**Trinity River Channel Rehabilitation Sites: Bucktail
(River Mile 105.3-106.35) and Lower Junction City (River Mile 78.8-79.8)**

**Final Environmental Assessment/Initial Study
DOI-BLM CA-N060-2014-014-EA and TR-EA0114**

Appendix B
Comments and Responses
on the Draft Bucktail and Lower Junction City EA/IS

Figure 19.B.2. Current proposed revisions to the upper portion of the Bucktail channel rehabilitation site design.

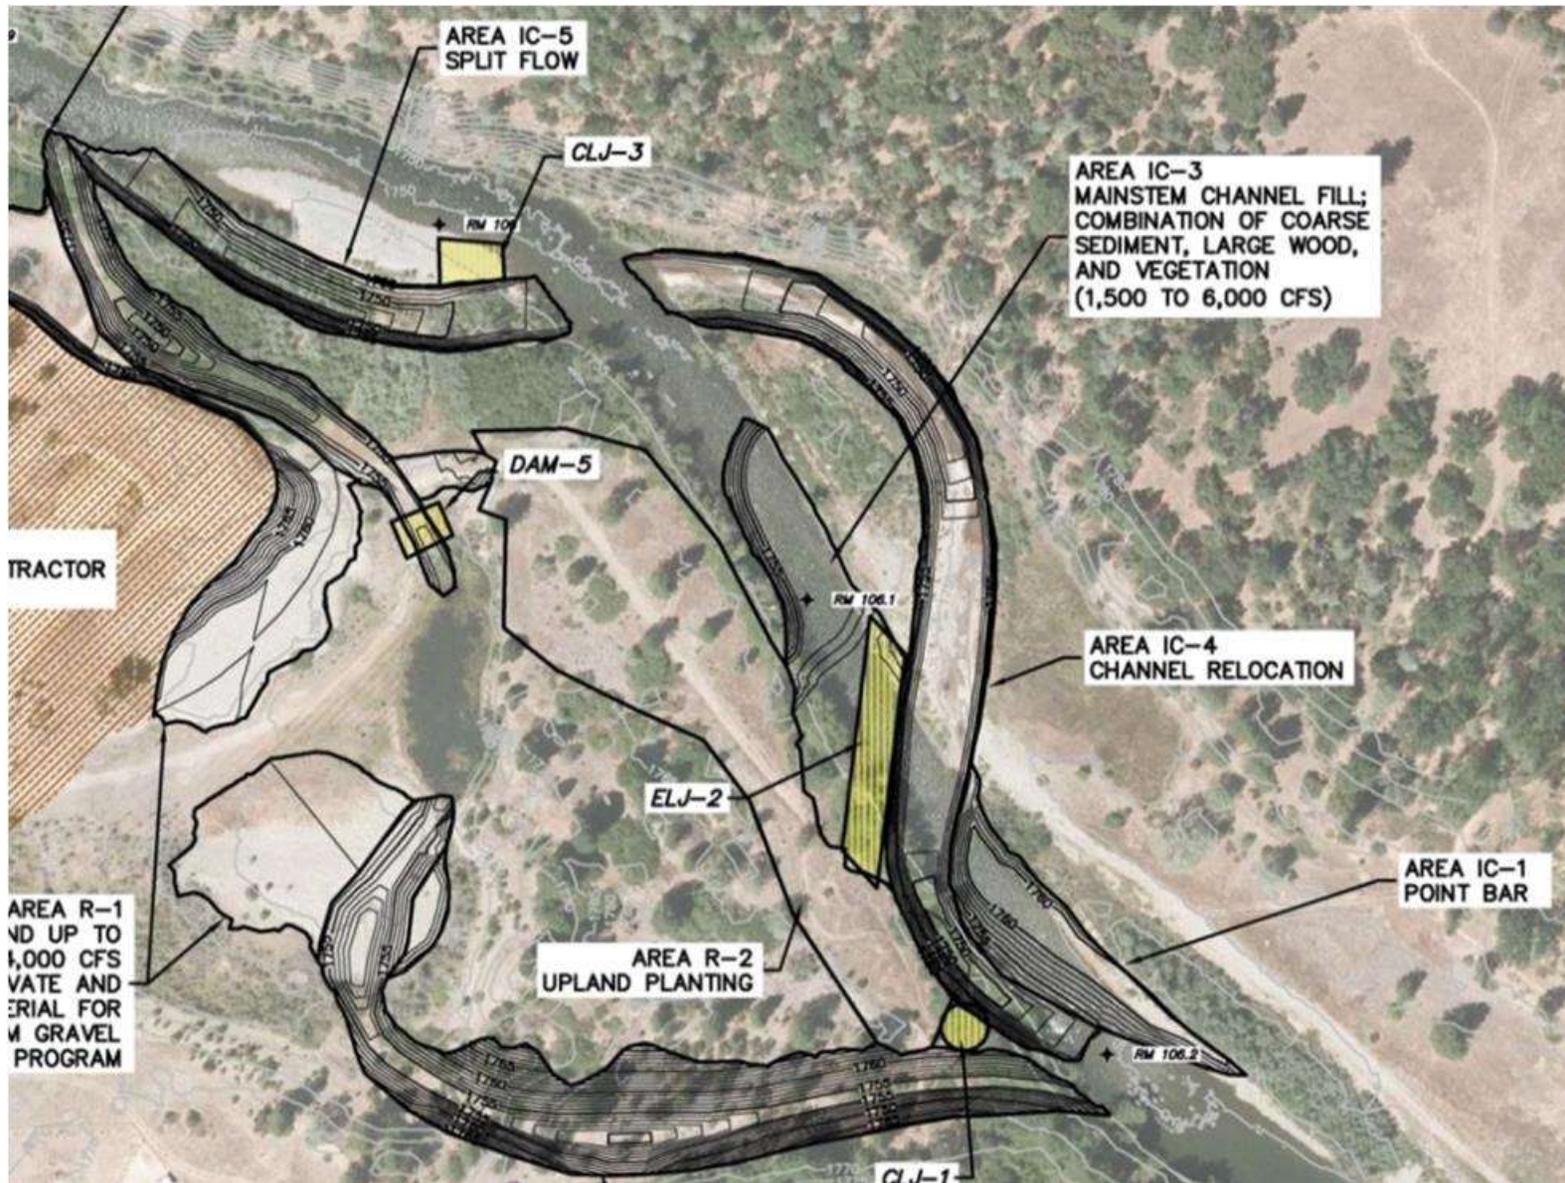
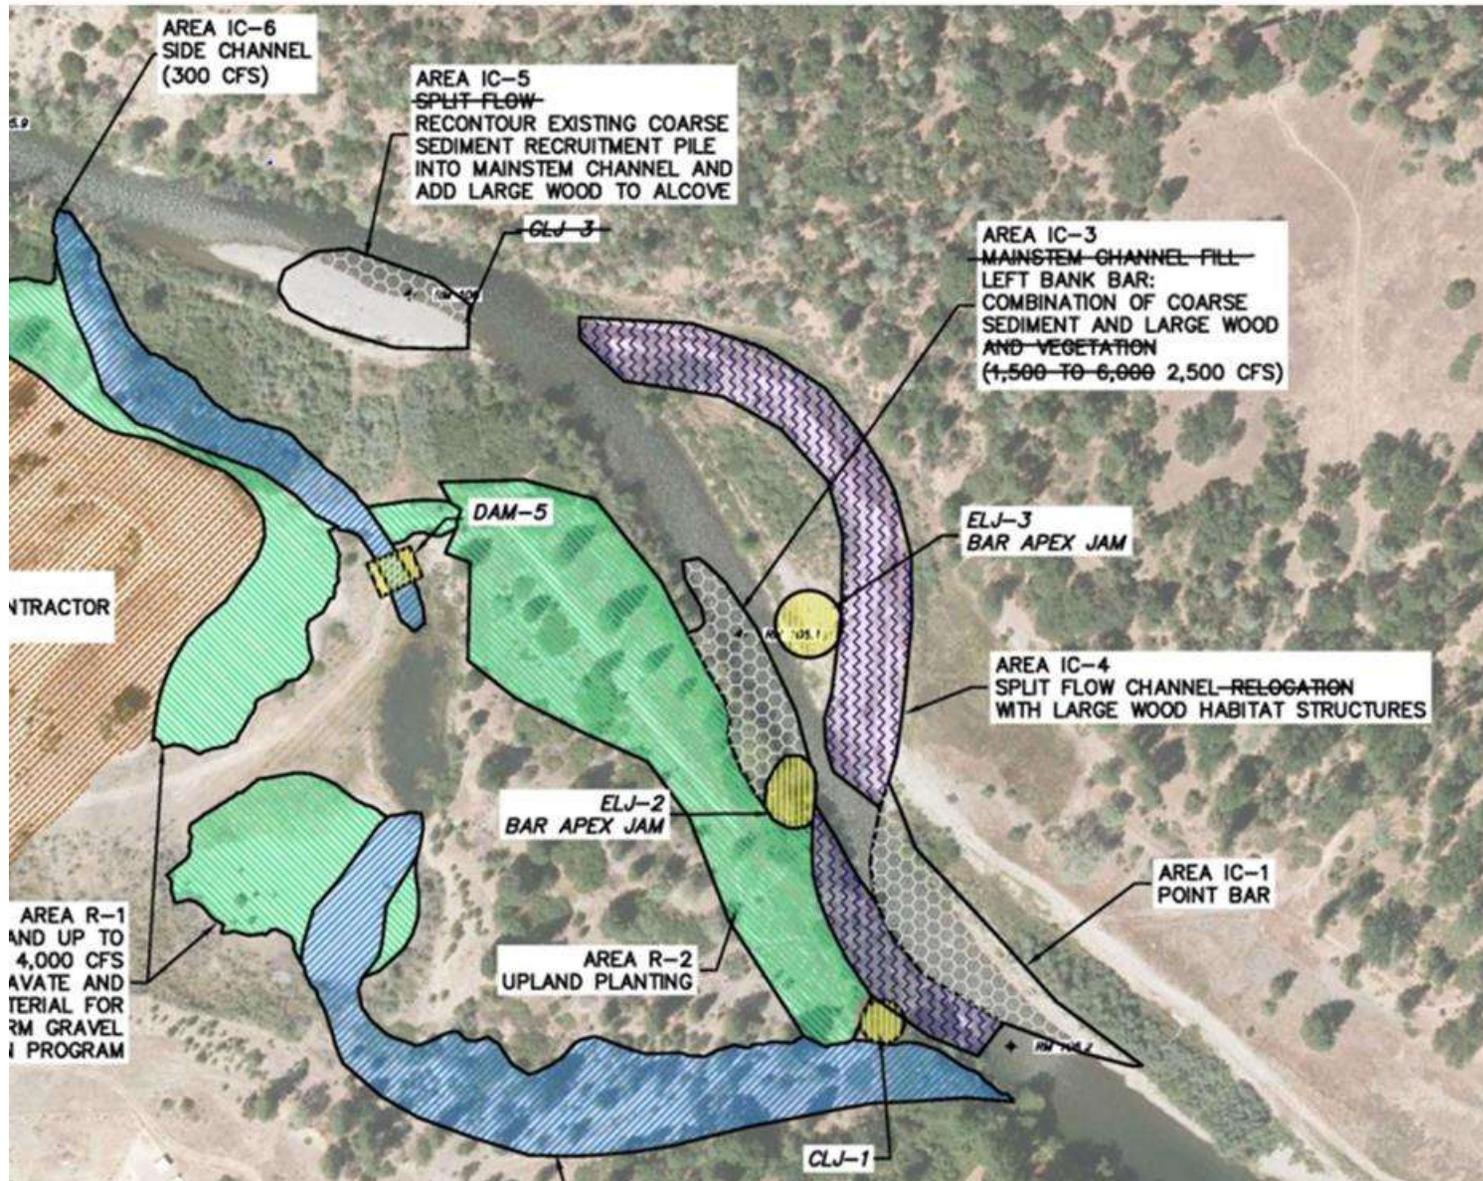
Comment 19.B – Bucktail design does not incorporate TRGA and public input.

The commenter notes that they have disagreed with the split flow and mechanical re-routing of the river. This is depicted at IC-4 in Figure 4 of the Draft EA/IS, and is shown in Figure 19.B.1 below.

The Bucktail design presented in Figure 19.B.1 (and in the Draft EA/IS) was the result of efforts to maximize juvenile salmonid habitat both immediately post-construction and into the future. Other factors leading to the design presented in Figure 19.B.1 included geomorphic and riparian design objectives. However, to achieve a successful relocation of the mainstem channel and achieve desired short and long term habitat benefits, it was determined that a large engineered log and rock structure, spanning the entire mainstem Trinity River channel, would be needed. This structure would have to be designed to survive maximum fisheries flow releases (approximately 11,800 cfs) to meet long-term goals. The size and stability of the proposed structure needed to relocate the river raised concerns that the channel would be unable to rework its bed and banks into the future.

Therefore, Project Areas IC-1, IC-3, IC-4, IC-5, and ELJ-2 design features are under revision to address both internal design group and public concerns.** The present concept, shown in Figure 19.B.2, includes a split channel without the engineered log jam (ELJ-2). This configuration and potentially other variations which are less extreme than that presented in the Draft EA/IS, will be evaluated to ensure that fish habitat, geomorphic, and riparian objectives are maximized, and that the risk of adverse long-term impacts (e.g., locking the channel in a fixed location) is minimized in the final Bucktail design recommended for implementation.

Modeling output of juvenile chinook fry and pre-smolt habitat for the current proposed Bucktail design configuration (Figure 19.B.2) versus the Draft EA/IS design (Figure 19.B.1) are compared in Table 19.B.1.

The current habitat area compared to the Draft EA/IS Bucktail design shows a 200% to 400% increase in Chinook fry and pre-smolt habitat for a streamflow of 1,200 cfs (Table 19.B.1, the lowest habitat area value for Draft EA/IS conditions). The side channels shown in Figure 19.B.2 (shown with blue fill), account for more than 50% of the overall habitat gains shown in Table 19.B.1.

Figure 20.A. Example Bank Naturalization Project.

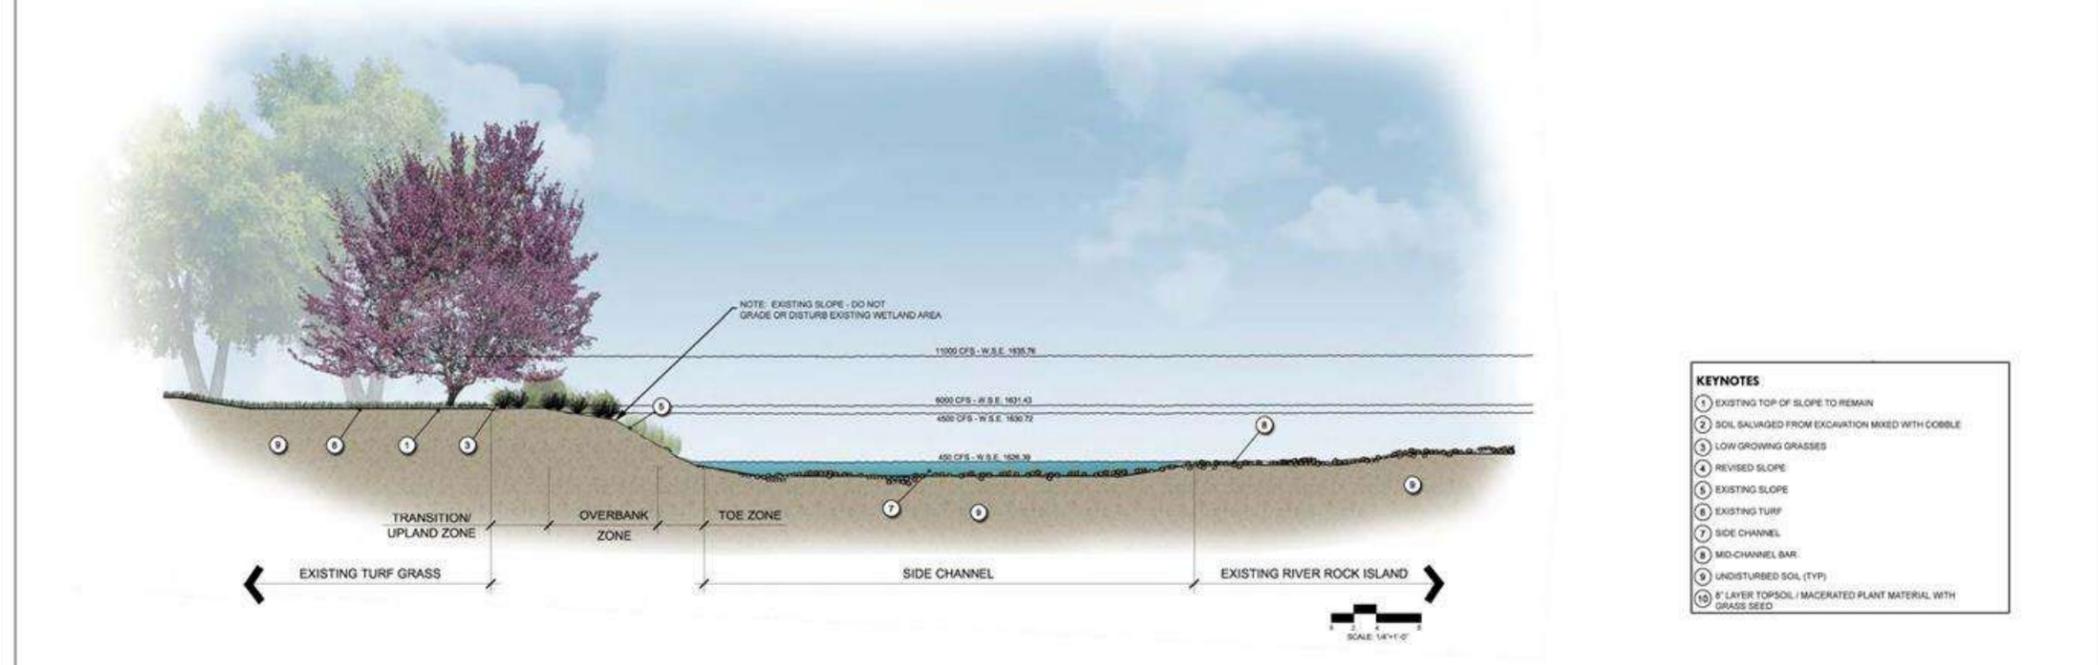
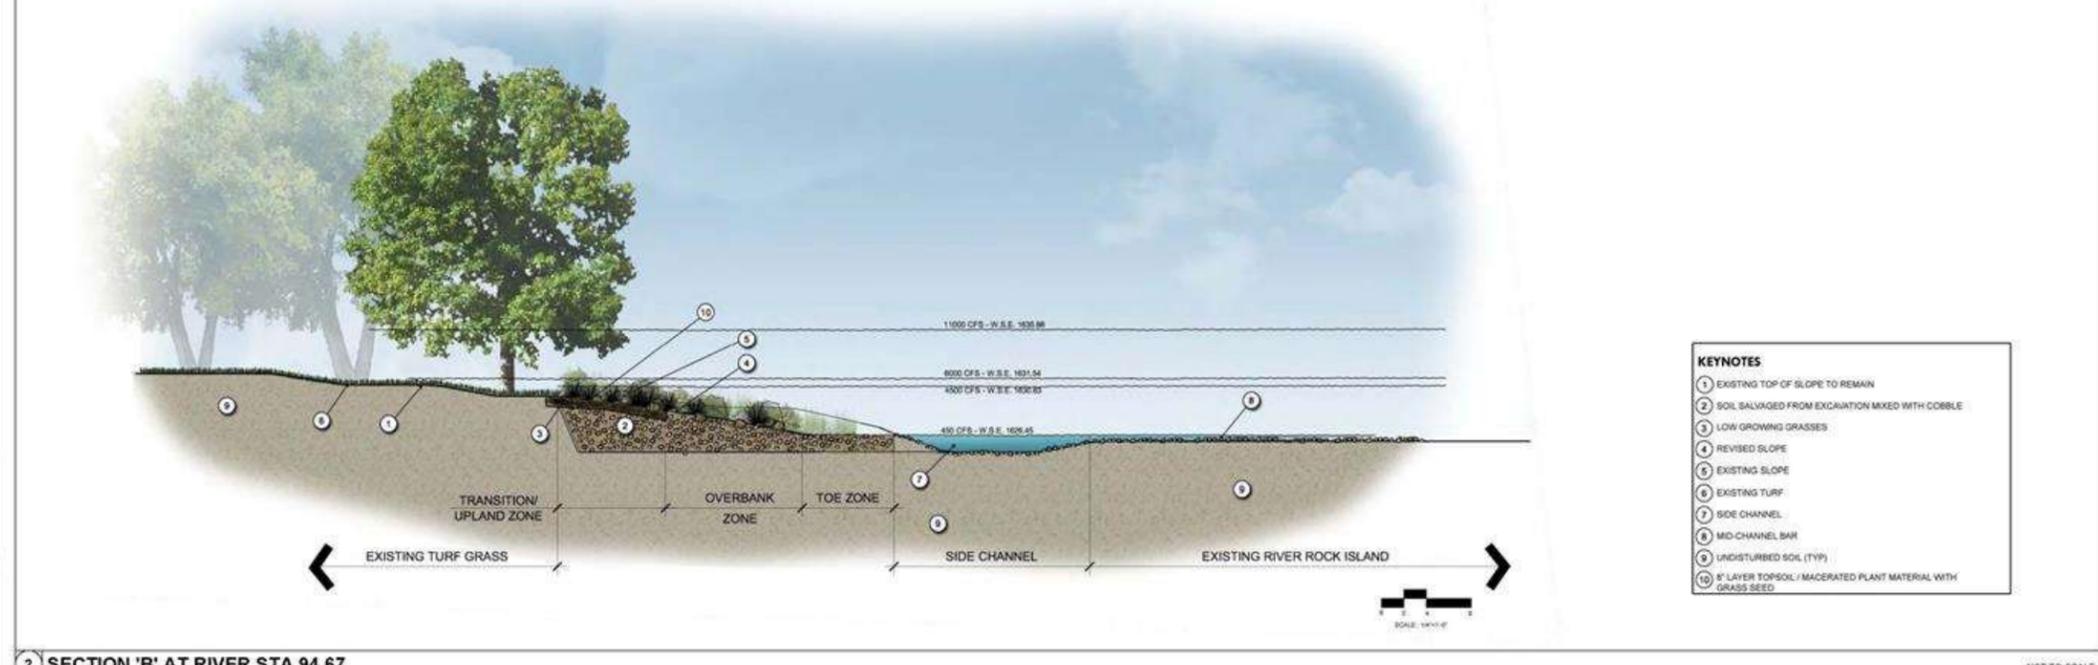
Comment 20.A – Tributaries have been ignored.

All project designs leveraged with TRRP funding such as a bank naturalization (biostabilization/revegetation) design provided to private landowners in 2013, are available upon request. Refer to Figure 20.A as an example.

Figure 20.D Total adult fall-Chinook escapement to Trinity River natural areas (River) above Willow Creek weir and TRH 2001-2012. (Draft figure from 2012 CDFW Trinity River basin salmon and steelhead monitoring project, 2012-2013 season report).

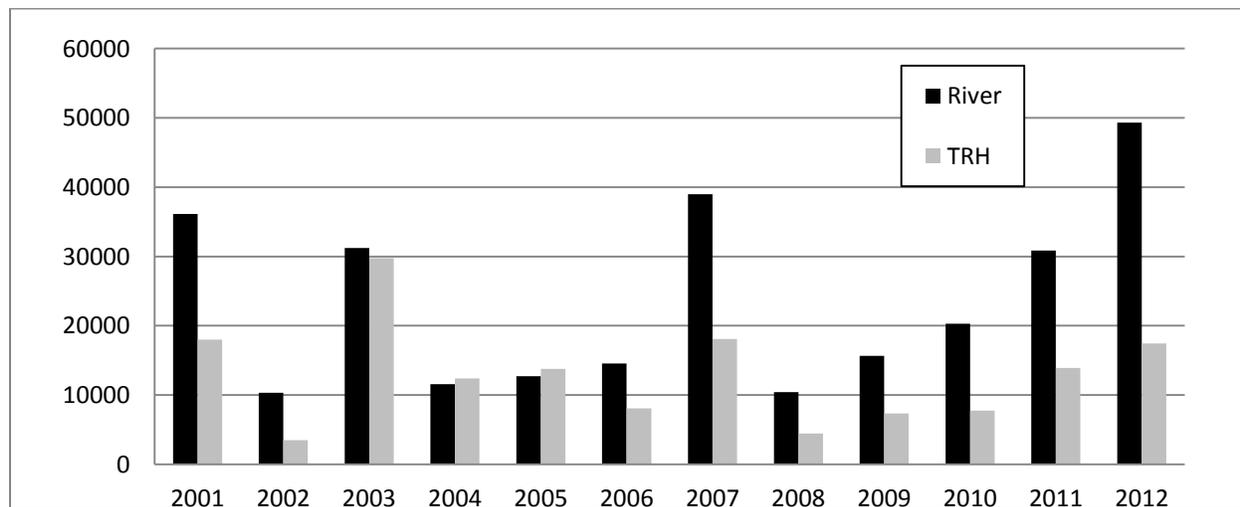
Comment 20.D – Dwindling adults result from unnatural gravel.

The ROD directed the TRRP to implement a gravel supplementation program in the reaches below the dam. The intent of introducing coarse sediment (gravel) downstream of the dams was to replace gravel that had washed downstream and not been replenished naturally since closure of the dam. Current evaluations now indicate that the post-dam coarse sediment deficit has been substantially reduced or possibly eliminated by TRRP augmentation (Gaeuman 2013); however, there will be a perpetual need to replace gravel that moves downstream from the Lewiston dam. The TRRP is now working to develop a long-term strategy to balance river transport with appropriate gravel augmentation. The plan will recommend a strategy and rationale to meet reach specific coarse sediment needs between Lewiston and Indian Creek so that ecological requirements (to sustain biological and physical processes) are met. A gravel management plan for public review and input is expected to be developed by fall 2014.

As for the number of spawning adults in the river, various factors, many of them outside of the Trinity Basin affect these numbers. The most recent California Department of Fish and Wildlife (CDFW) annual report for the Trinity River Basin Salmon and Steelhead monitoring project 2010-11 season (Sinnen et al. 2013; <http://odp.trrp.net/Data/Documents/Details.aspx?document=2120>) suggests that the natural contribution of fall run Chinook salmon upstream of Willow Creek has been increasing over the last 10 years, and that overall salmon and certainly steelhead numbers have also been trending positively. Figure 20.D below, produced from 2012 CDFW data, also supports this increasing trend in naturally produced Trinity River fall-Chinook salmon.

Figure 21.A.2. Displays river discharge measured at the Douglas City gauge from August 12 to August 15 (plotted from USGS gauge 11525854 at Douglas City; http://waterdata.usgs.gov/ca/nwis/uv?site_no=11525854).

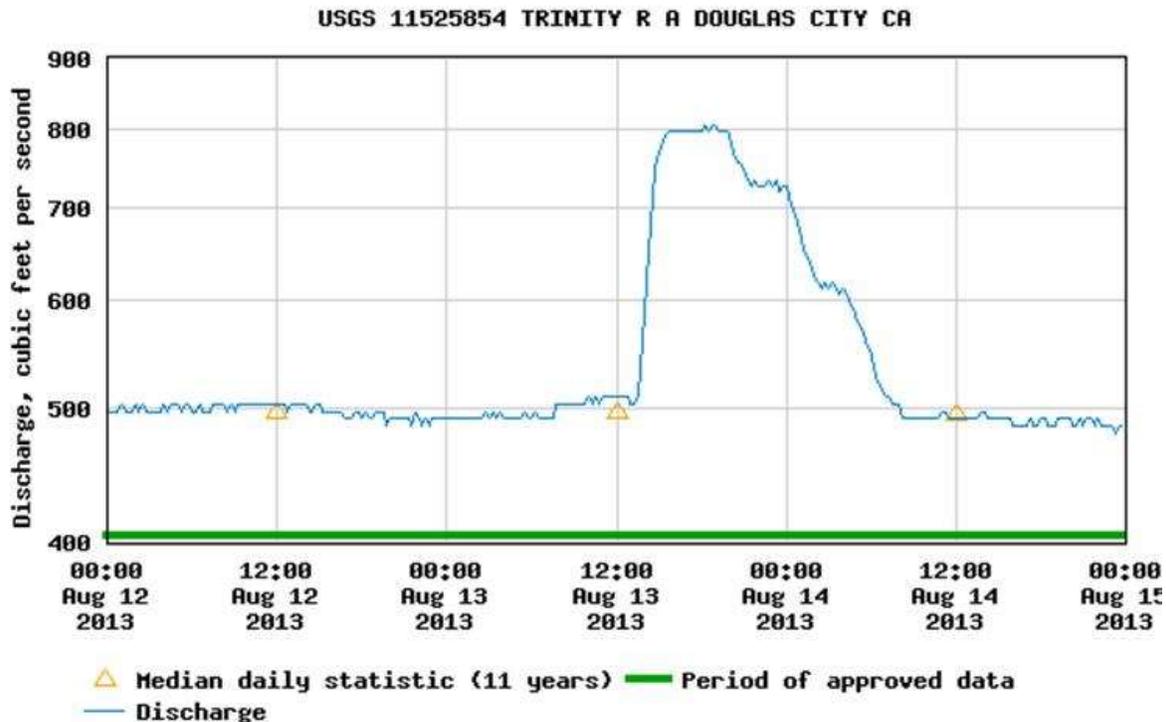
Comment 21.A. – Turbidity downstream on August 14-15, 2013.

During the August 14-15, 2013 period, the contractor was finishing construction of the in-channel meander (IC-7) and island (IC-6) downstream of the Douglas City (Highway 299 Bridge; Figure 21.A.1). The excavated material at IC-7 was the siltiest found in the entire 2013 project and required the contractor to slow excavation to stay within permit conditions. What is more, on August 13 a pulse of water between 500 and approximately 800 cfs was released from Lewiston dam for about 16 hours between 8 am and midnight. This relatively high flow release, shown in Figure 21.A.2 (at the Douglas City gauge), may have disturbed newly wetted areas the length of the river upstream of the construction site as well as at the newly excavated and silty IC-7. Both may have contributed to the overall turbid conditions seen by the commenter at that time. While Dutton Creek turbidity, stated by the commenter, was more noticeable than under “normal construction” conditions, the project activities were conducted within permit levels. Operations within these levels are considered protective of the Trinity River fishery.

Due to the nature of the proposed river restoration activities and the clarity of the Trinity River during low flow conditions, the Regional Water Board determined that an allowable zone of turbidity dilution is appropriate and necessary in order for Trinity River restoration activities to be accomplished in a meaningful, timely, and cost-effective manner that fully protects beneficial uses without resulting in a violation of the water quality objective for turbidity. Consequently, the Regional Water Board worked with TRRP to develop the water quality mitigation measures that are included in the TRRP’s general permit (Order Number R1-2010-0028) and that are followed on TRRP projects today. These mitigation measures are considered workable to allow construction of river restoration projects but conservative enough to protect beneficial uses (NCRWQCB and USBR 2009).
